Project Reference: ERC0222

We refer to the AEMO Electricity Rule Change Proposal - Generator Technical Requirements document issued on August 11, 2017.

Project Reference: ERC0222
GE views on AEMO Electricity Rule
Change Proposal

Typical steady-state stability limit and power chart for synchronous generators

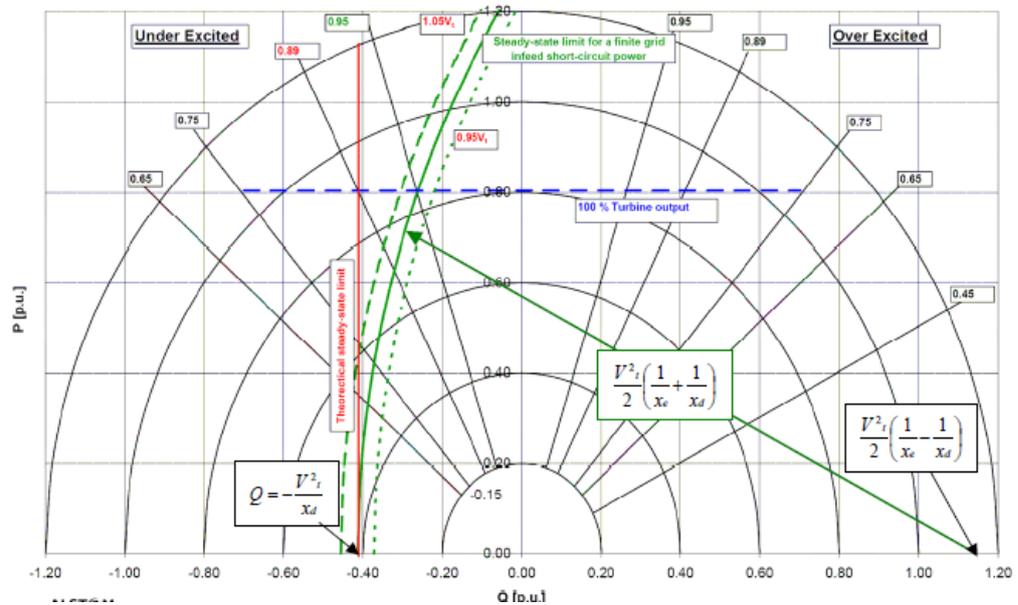
With reference to AEMO [1], Section 5.4.3, Figure 2, GE interprets the change as requiring synchronous generating systems to be able to absorb reactive current of up to 250% of rated current, when the voltage drops to 50%. GE's concern is with regards to steady-state stability limits especially when operating at the leading power factor range.

Referring to the typical synchronous generating system power-chart below, the amount of reactive power that can be absorbed without violating the steady-state stability limit (red line) of the unit depends on several factors such as:

- The external reactance X_e (grid and transformer).
- The generator synchronous reactance X_d .
- Generator terminal voltage V .
- The active power P being generated.

GE would like to have further clarification on how the abovementioned technical limitation and operating constraints are considered in this rule change and if further technical parameters will be provided for generators to assess compliance to this proposed standard.

Typical V/Hz protection for synchronous generators.

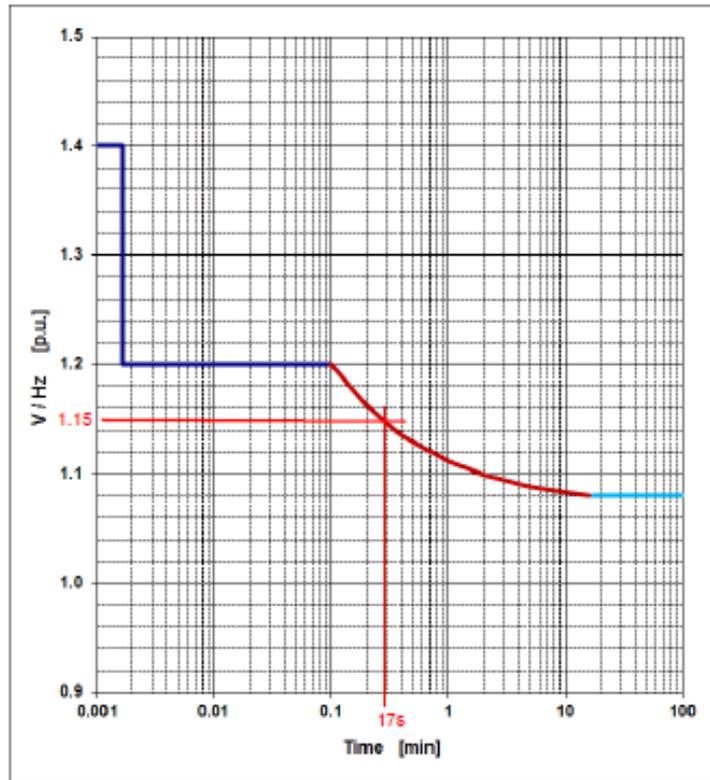
With reference to AEMO [1], Section 5.6.3, Figure 5 and Table 6, GE interprets the change as requiring synchronous generating systems to be able to withstand over-voltages in the range of 110-115% for 1200s. GE's concern is with regards to V/Hz over-fluxing design of transformers and generators. According the IEEE [2], a typical V/Hz protection for synchronous generator is shown in the figure below. The proposed change does not mention if this standard also requires the consideration of simultaneous under-frequency disturbance. If an under-frequency disturbance of 47.5 Hz for 2 minutes, according to NER Rules S5.2.5.3, is considered with an overvoltage of 115%, this will lead to a V/Hz of 1.21pu, causing the V/Hz protection relay to trip the unit.

GE would like to have further clarification on how the abovementioned technical limitation and operating constraints are considered in this rule change and if further

technical parameters will be provided for generators to assess compliance to this proposed standard.

Automatic Access MLVDRT

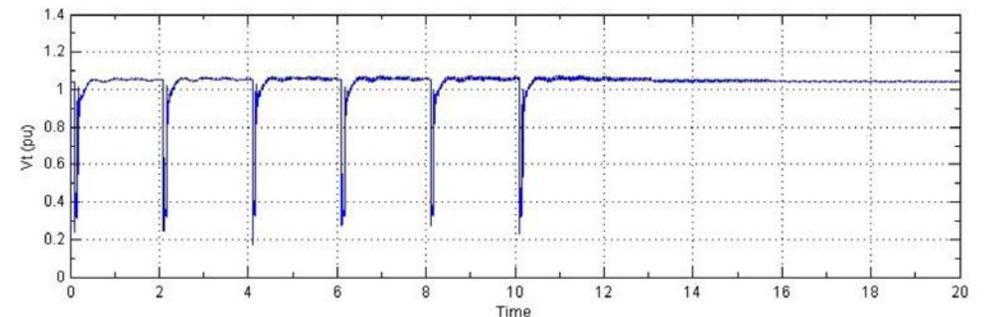
The automatic access standard is that a generating system and each of its generating units and reactive plant must maintain continuous uninterrupted operation for up to 15 voltage disturbances in any 5-minute period causing the connection point voltage to drop below 90% of normal voltage for a total duration of 1,800 milliseconds.

- Define the voltage-time curves referenced by the automatic access standard.
- Define in detail, the type of fault (3, 2 or 1 ϕ), fault duration and the number of faults. (see diagram right).
- Define pre-fault condition and post-fault condition.

AEMO could define conditions that cannot be fulfilled with present status-of-the-art synchronous generating systems

ROCOF requirements

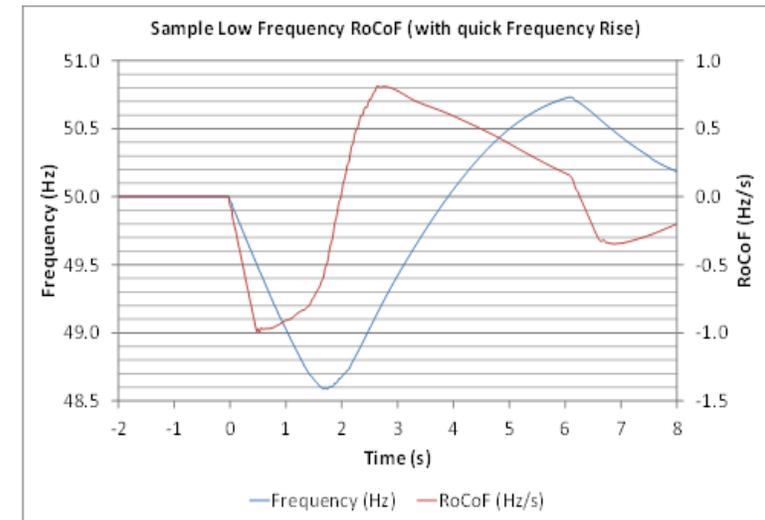
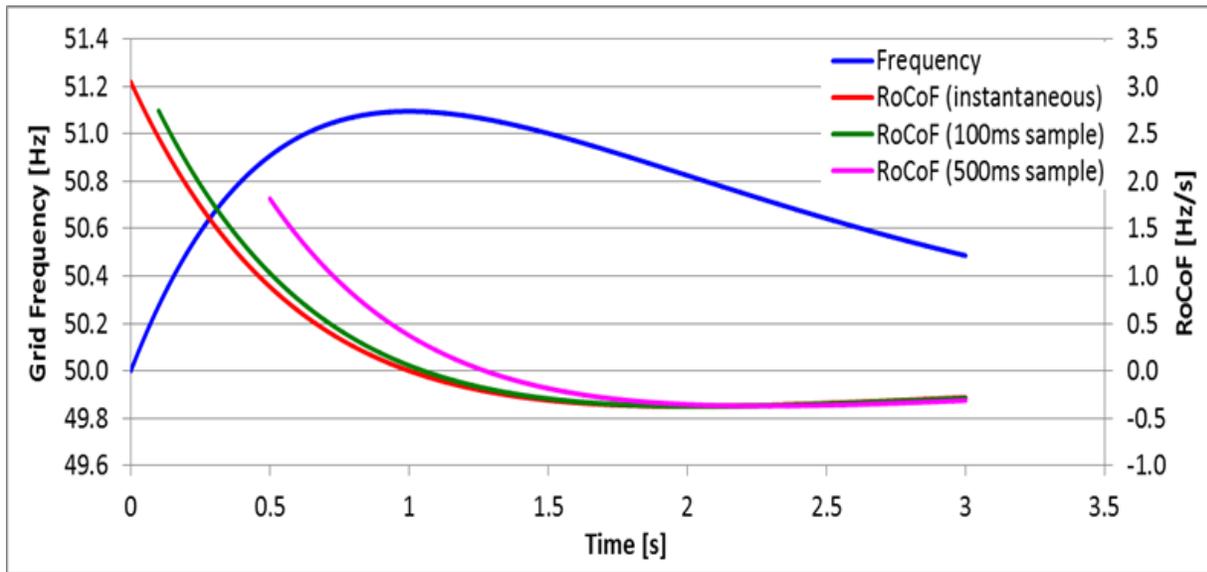
- AEMO:
 - Define the frequency-time curves referenced by the automatic access standard. See proposals on next slide.
 - Define pre-fault condition and post-fault condition.

- AEMO to define:
 - Measurement conditions for the RoCoF value (see diagram left)
 - Expected wave shape(s) of the frequency excursion (see diagram right)

Generator inertial response

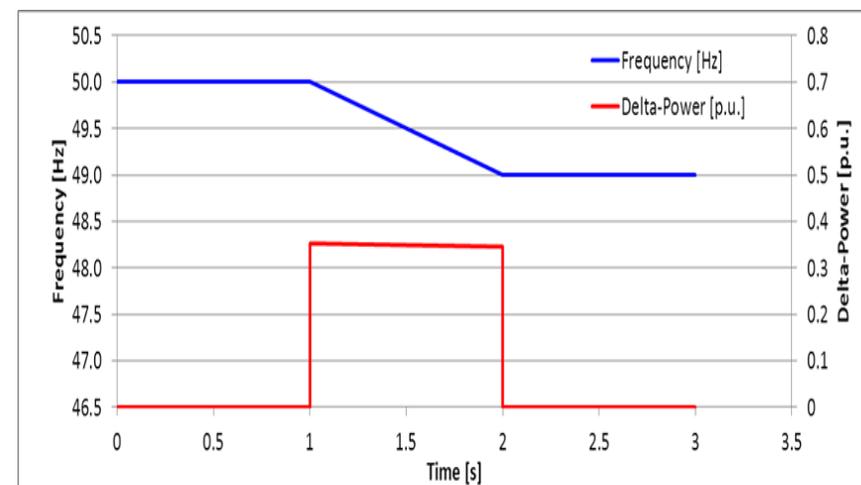
- Frequency changes with constant gradient
→ immediate power step (inertial response) request at generator terminals.
- Step is deceleration or acceleration power of shaft line
- Negative frequency gradients are critical:
→ generator load angle increase
→ exported power increase

Rate of Change of Frequency	Resulting immediate Power Step ΔP (example, typical GT single drive shaft train)
0.5 Hz/s	17.5 %
1.0 Hz/s	35 %
2.0 Hz/s	70 %
3.0 Hz/s	105 %
4.0 Hz/s	140 %

High ROCOF values can result in the unit pole-slipping.

- **ROCOF profile(s) to be defined and used as reference for simulation**
Requirements for simulation against the detailed frequency-time profiles and related results can be used as a mean to check/keep and define clearly existing requirements for a specific point of connection. A case by case assessment is a necessity. Both transient stability and shaft integrity issues must be addressed. Protection against out-of-step operation and damage of the shaft-line must also take precedence as this is a safety issue.
- **Consider reasonable ROCOF withstand capability**
As in the case of EirGrid, a value of 1 Hz/s measured over 500ms could be considered. If higher values are needed, then these should be justified with a detailed study.
